ADDENDUM NO. 0

Date: May 11, 2022

Project: **SCUSD Project No. 454-1**
Shade Structures Group 1A

PROJECT NO. 21-1504.05
 DATE: 04/29/22
 SHEET **C1.1**

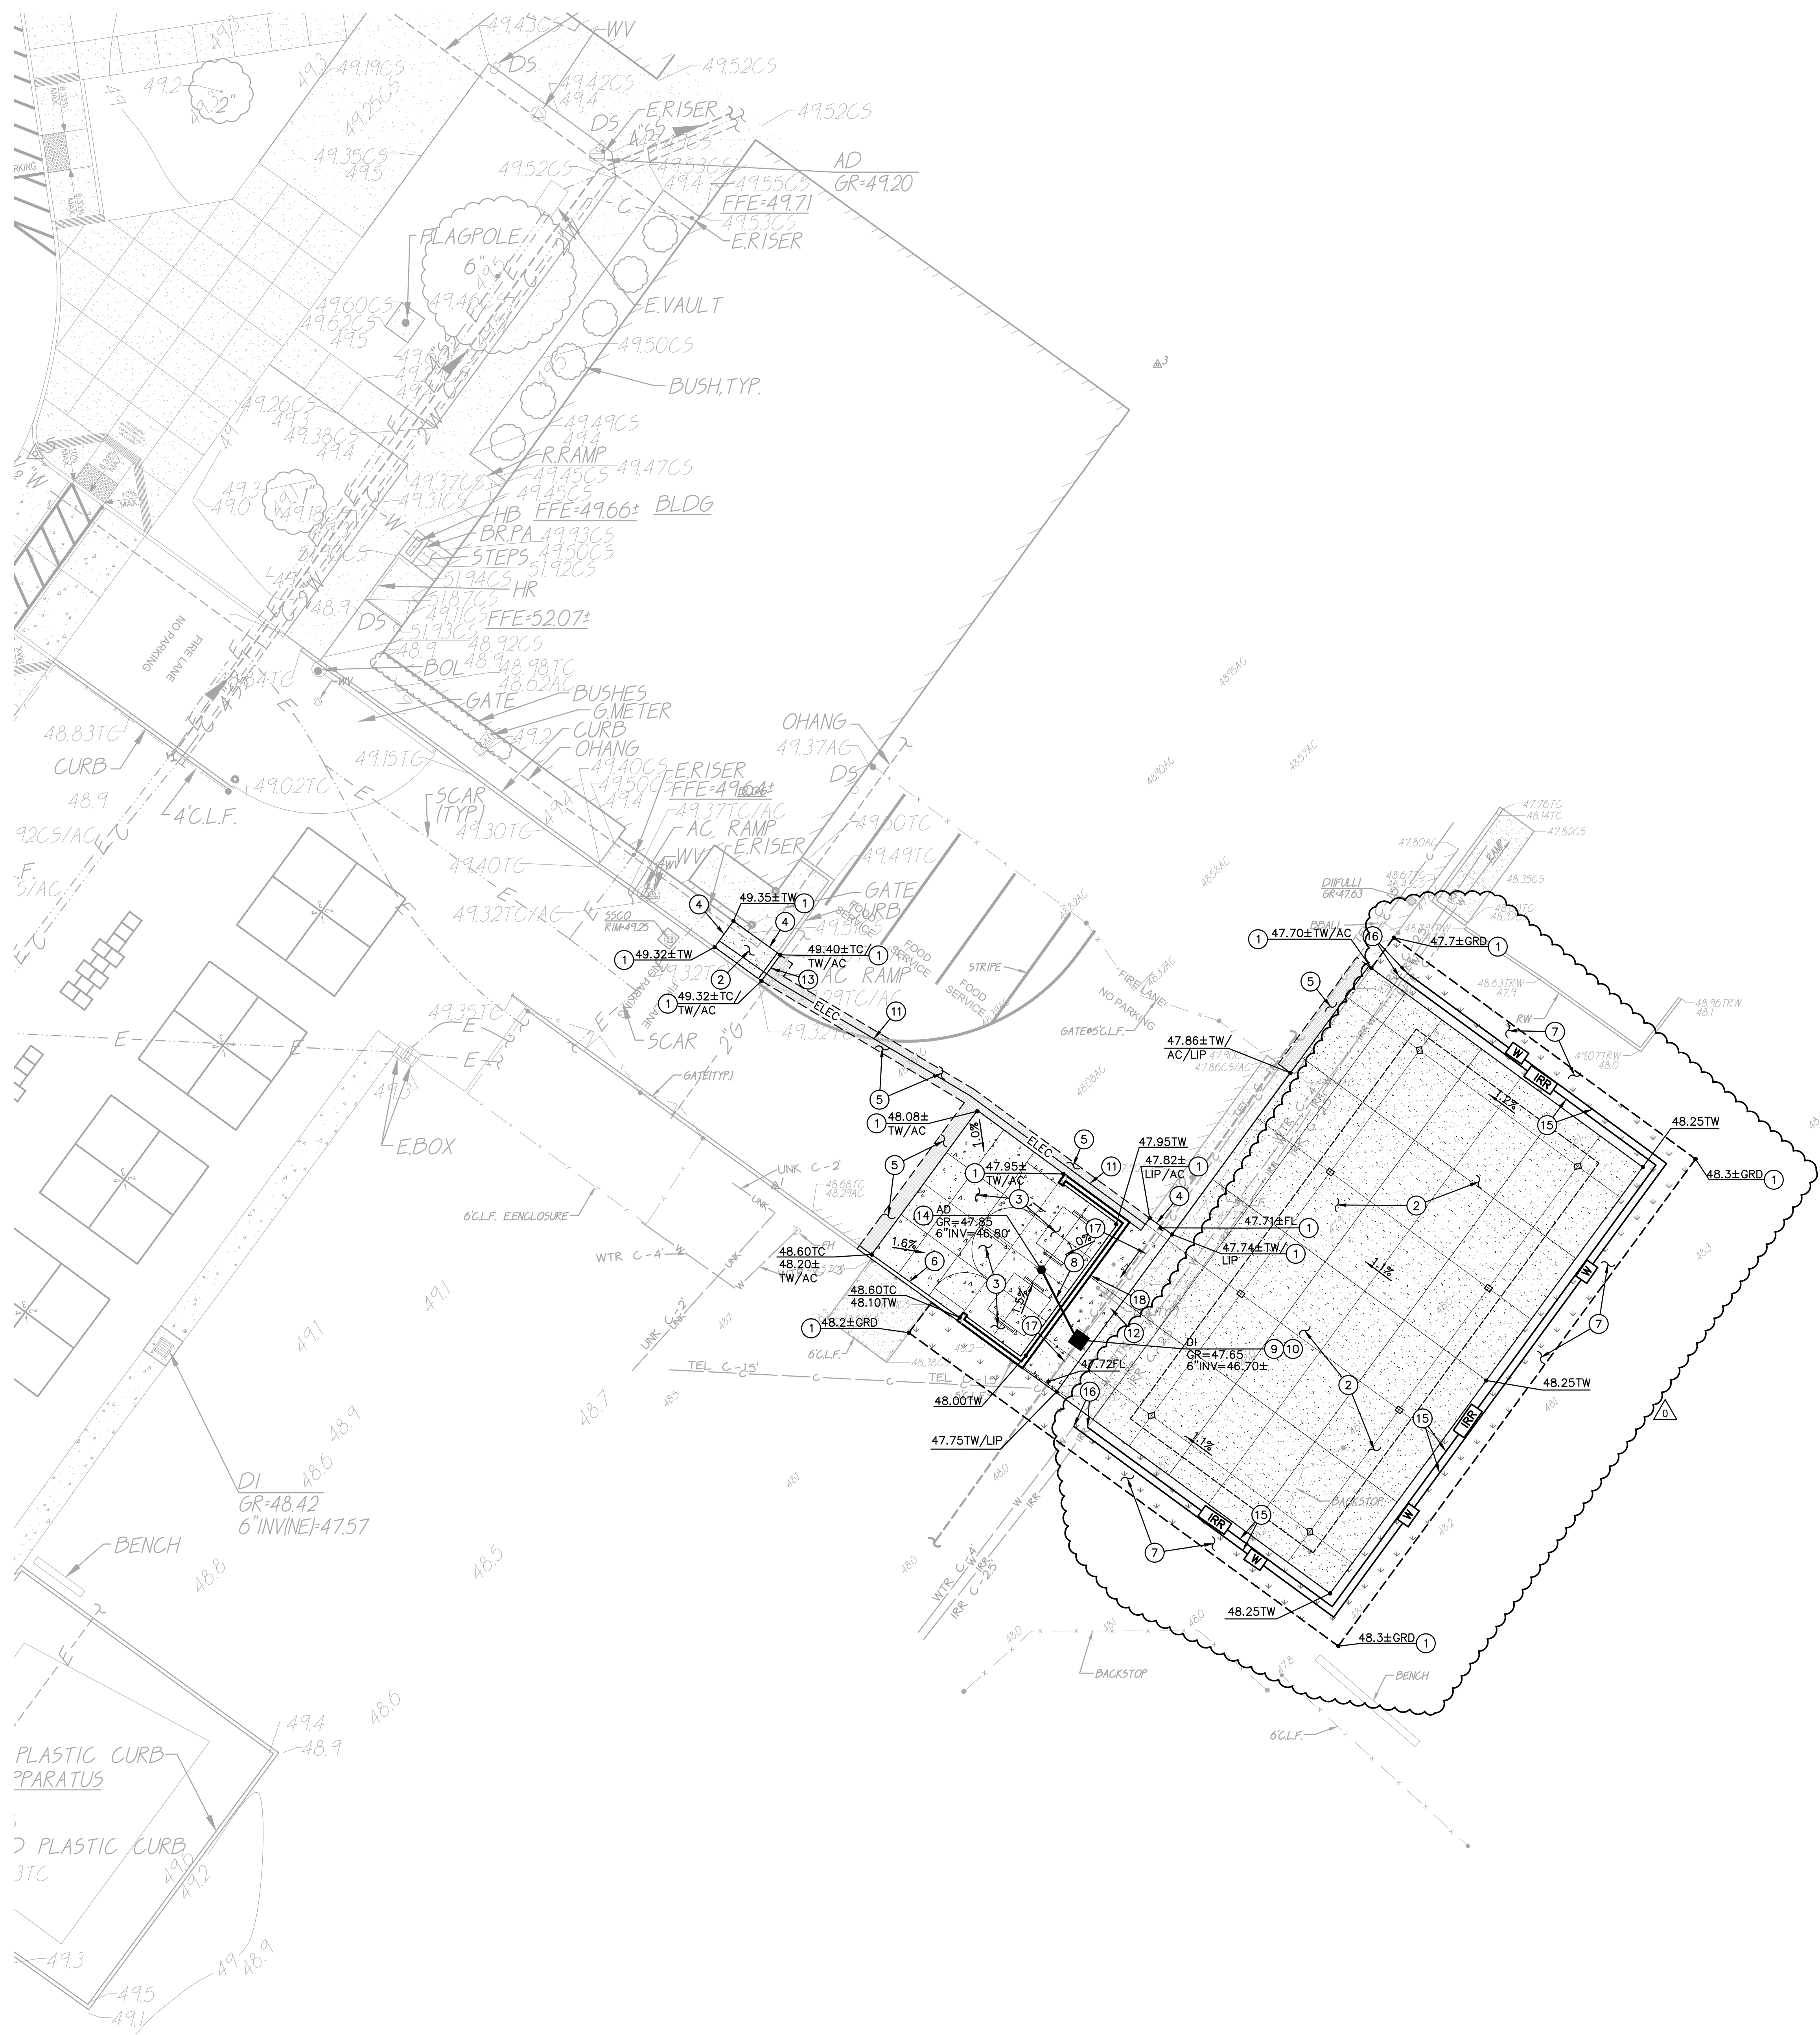
1. REVISE existing water and irrigation line demolition scope and all applicable callouts to now include demolition of the existing water line per sheet AD0.02 included with this addendum.

2. REVISE Demolition Note 10 per sheet AD0.02 included with this application
- C. Sheet C2.1, Grading, Drainage and Paving Plan
1. REVISE water and irrigation line scope and all applicable callouts to now show the rerouting of the utilities around the shade structure concrete pad per sheet AD0.03 included with this application.

ADDENDUM **0**
 DATE: 04/29/22
 PROJECT NO.: 21-1504.05
 SHEET: **AD0.04**

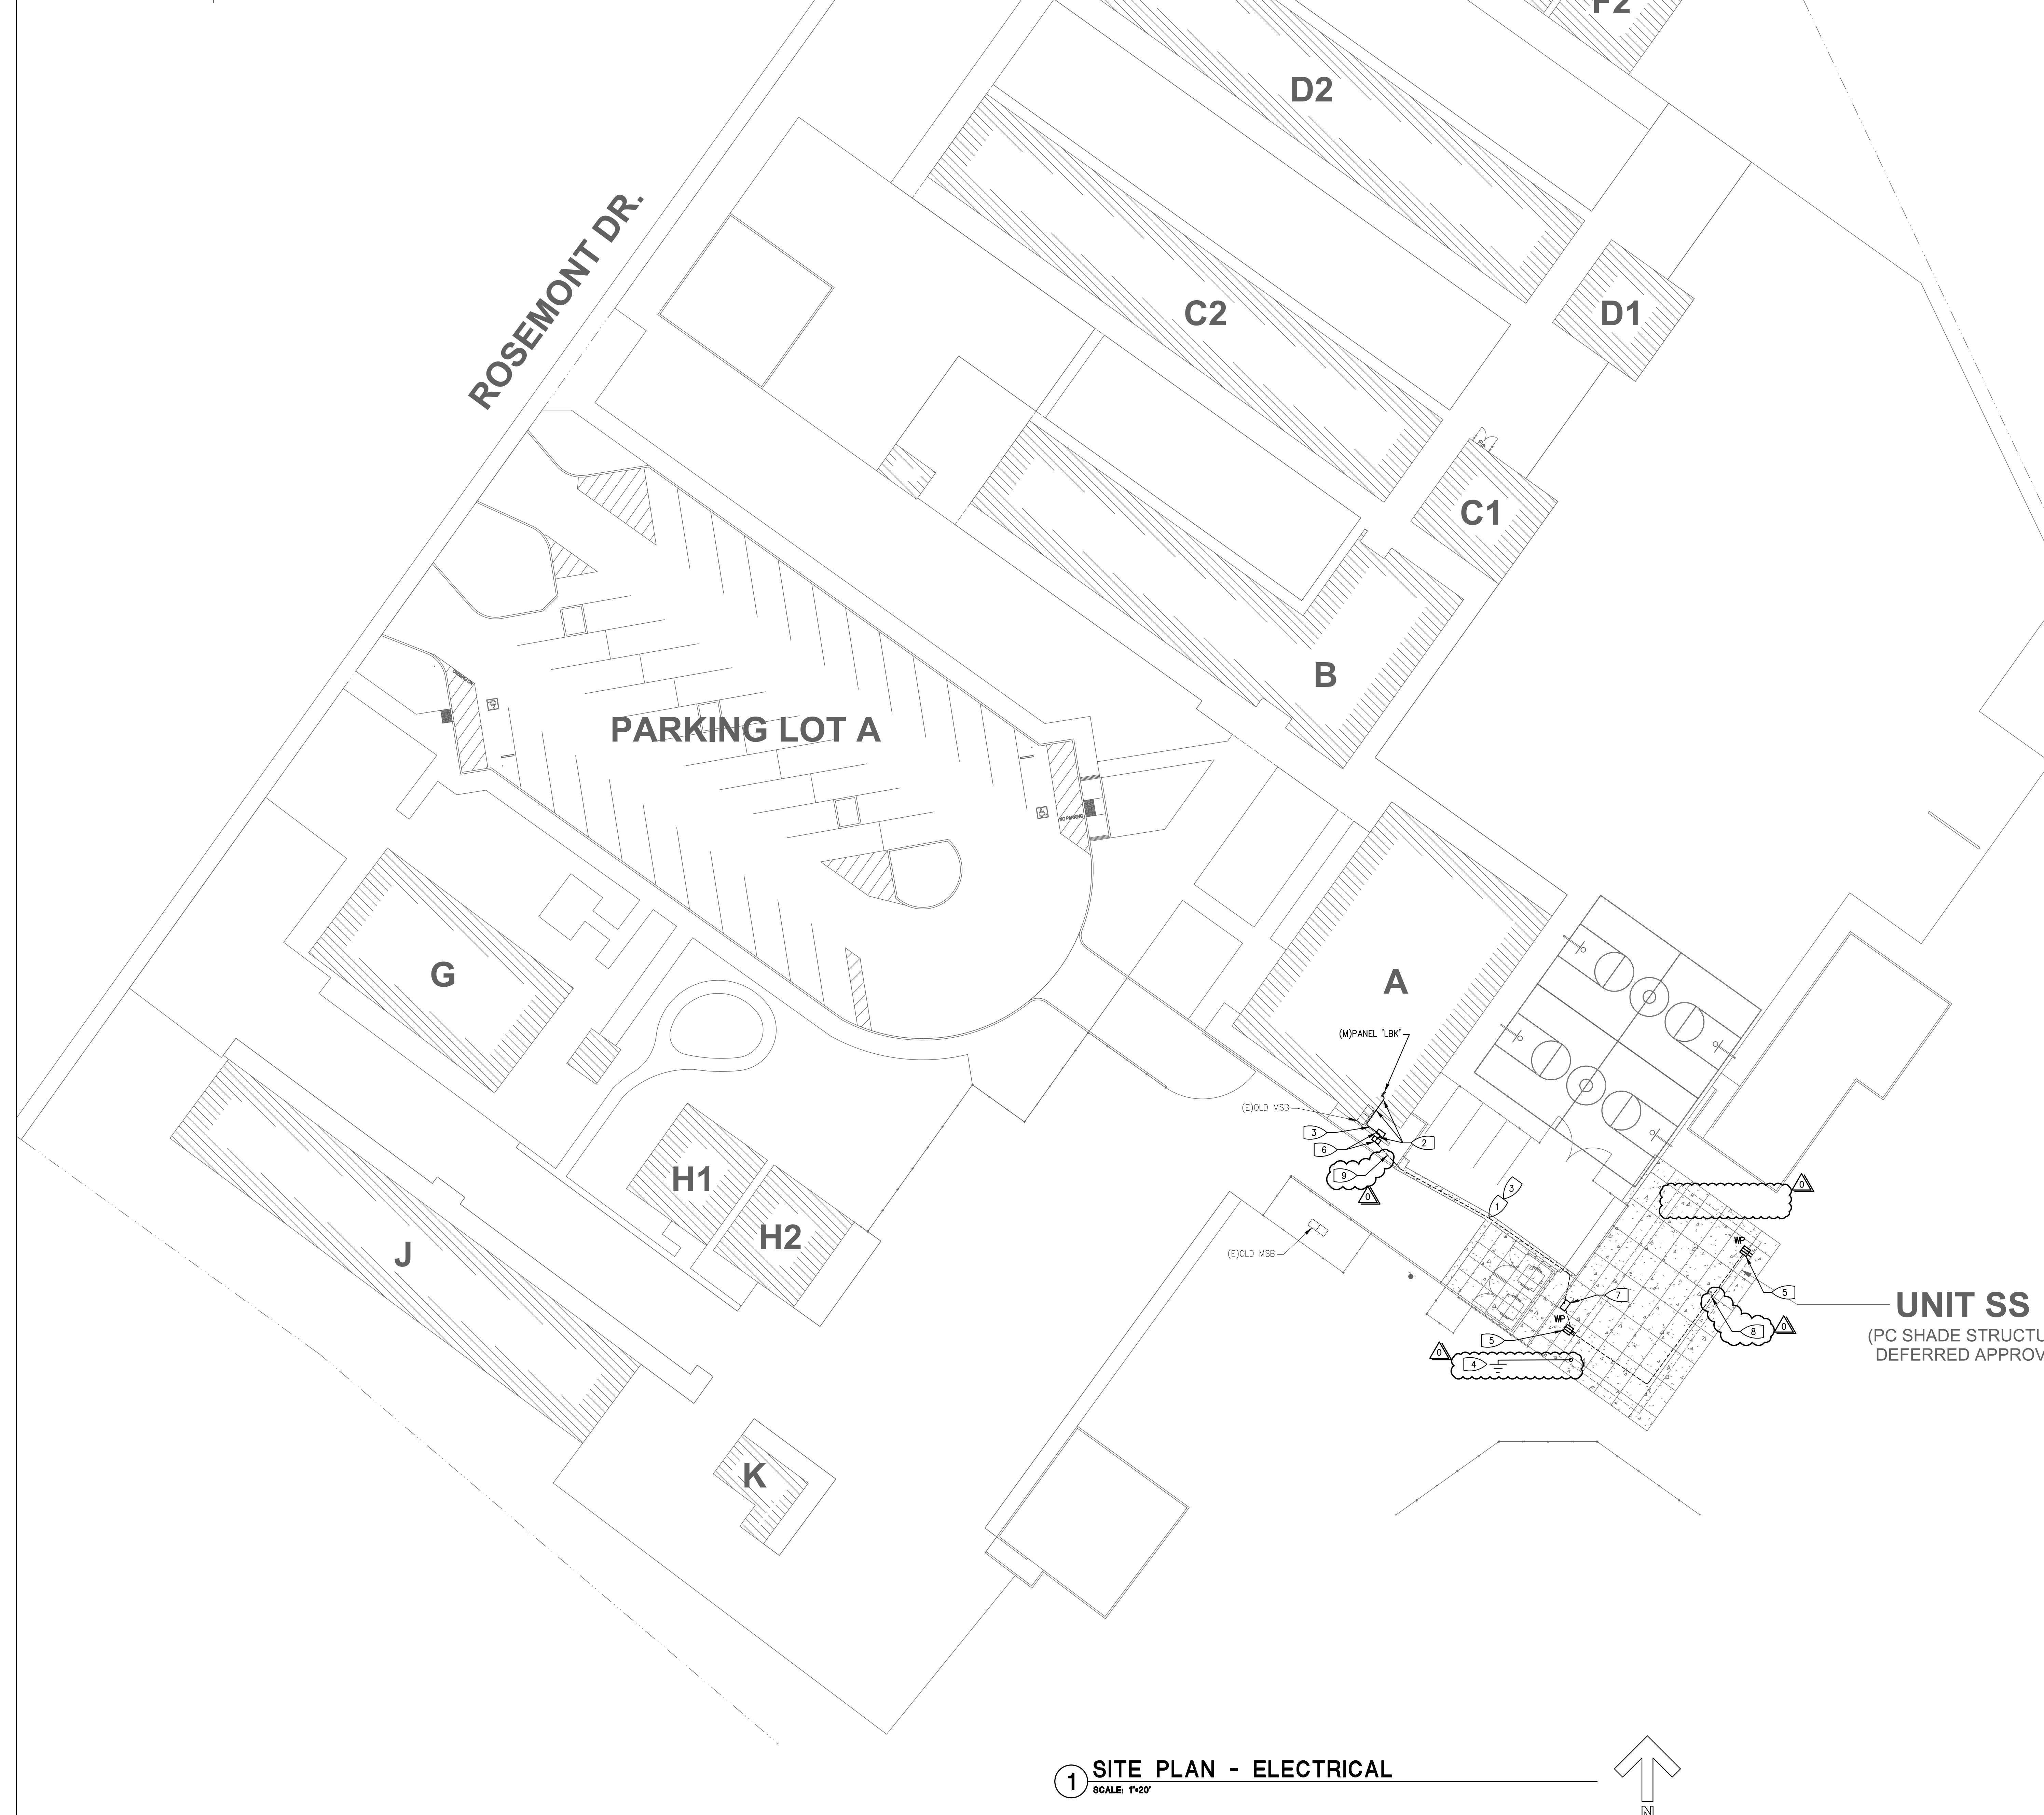
2. REVISE Construction Notes 15 and 16 per sheet AD0.03 included with this application.
- D. Sheet A1.1.1, Partial Site Plan and Details
1. Detail 2, Site Plan – Shade Structure: REVISE site plan to now show a section callout at the shade structure column per sheet AD0.04 included with this addendum.

2. Sheet Note 4: ADD note. Text to read “For footing / concrete pad / column Interaction, see PC shade structure / deferred approval”
- E. Sheet E1.1, Site Plan - Electrical

PROJECT NO.	21-1504.05
DATE:	04/29/22
SHEET	E3.1

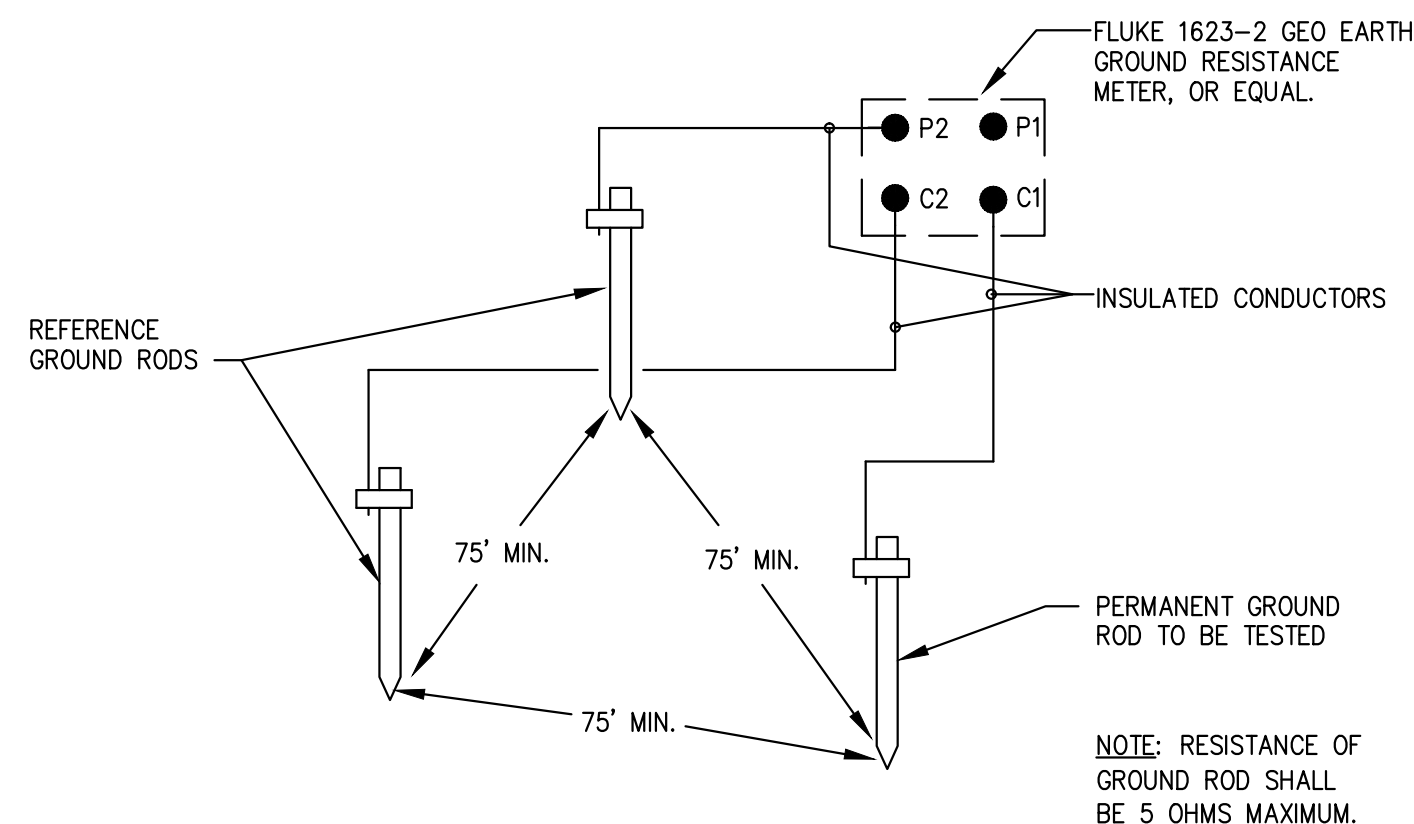
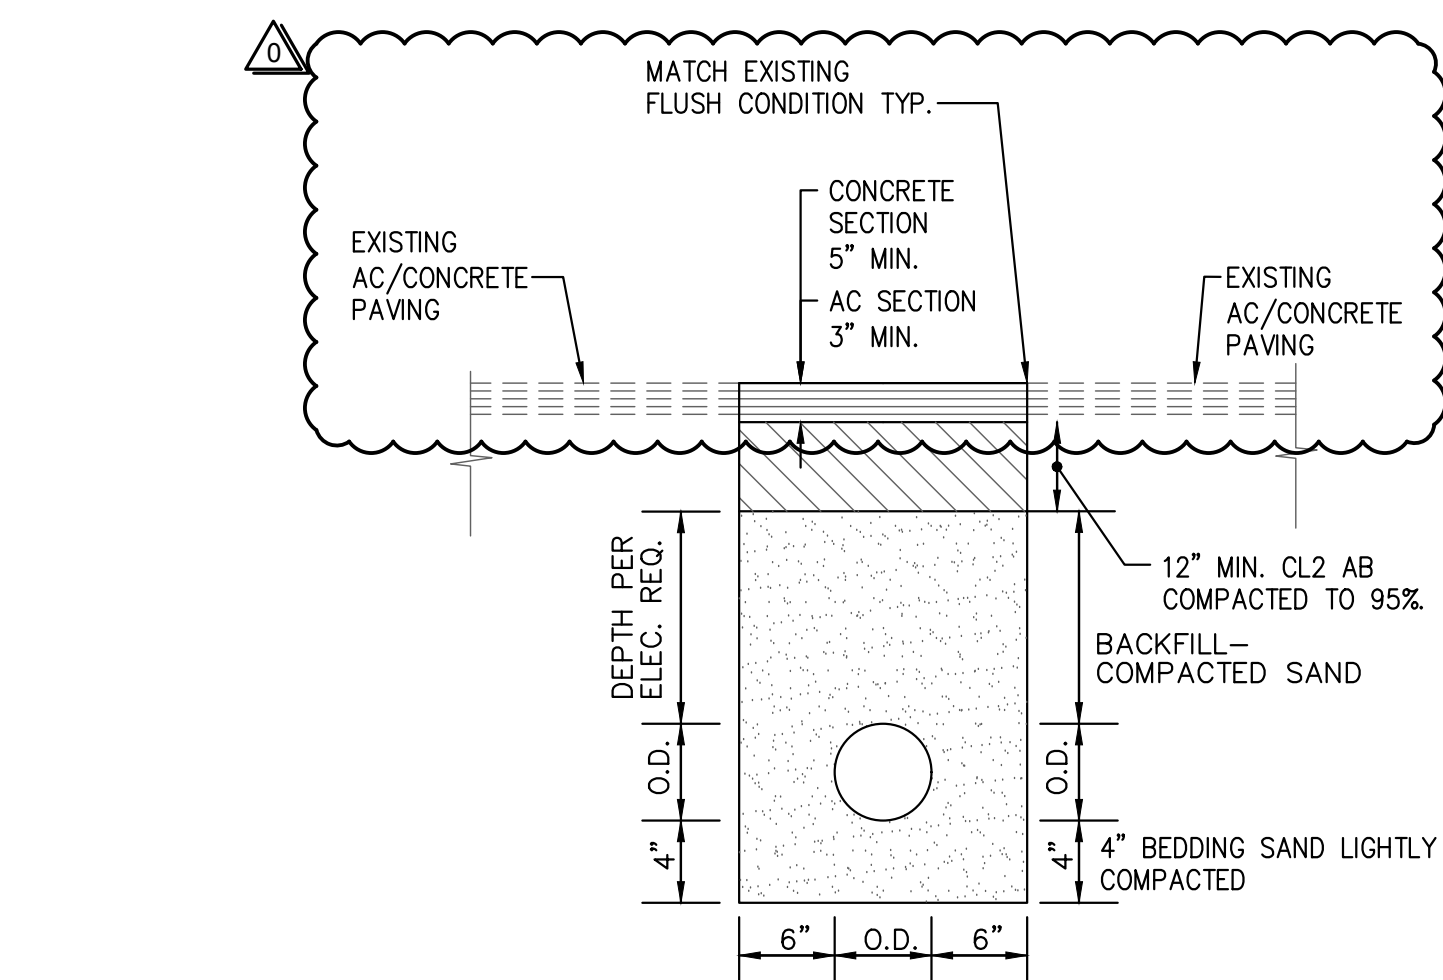
3. ADD Keyed Notes 8 and 9 per sheet AD0.05 included with this addendum.
- F. Sheet E3.1, Details
1. Detail 2, Typical H/20 Traffic Rated Pull Box: REVISE per sheet AD0.06 included with this addendum.

2. Detail 3, Typical Trench Detail: REVISE per sheet AD0.06 included with this addendum.
 3. Detail 4, Conduit Stub in Post Detail: REVISE per sheet AD0.06 included with this addendum.

4. Detail 5, Typical Steel Column & Rebar Grounding Detail: REVISE per sheet AD0.06 included with this addendum.
- G. Sheet 2, Statement of General Conformance
